Invitation For Bid
GSA-028-24
Workstation Cubicles and Office Furniture

Questions and Concerns received from Americana Suppliers on August 23, 2024.

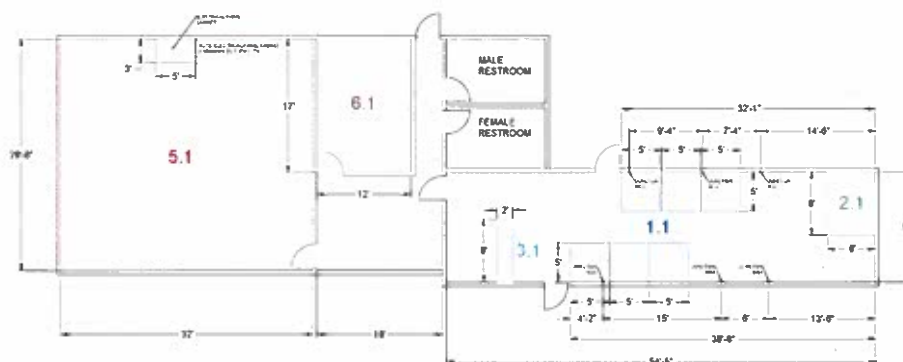
19. We noticed Line Item 4.1 Workstation Cubicles for the Financial Officer were not mentioned in the site visit conducted on August 30, 2024. Kindly assist in locating which portion in the initial layout below it will be placed.

20. Kindly examine the initial layout and verify if cubicles are in their desired location.

Response: See Amendment #3.

Response: 1.1 Yes, 2.1 No, 3.1 Yes, 4.1 No, Workstation Cubicle, 5.1 Yes, 6.1 Yes
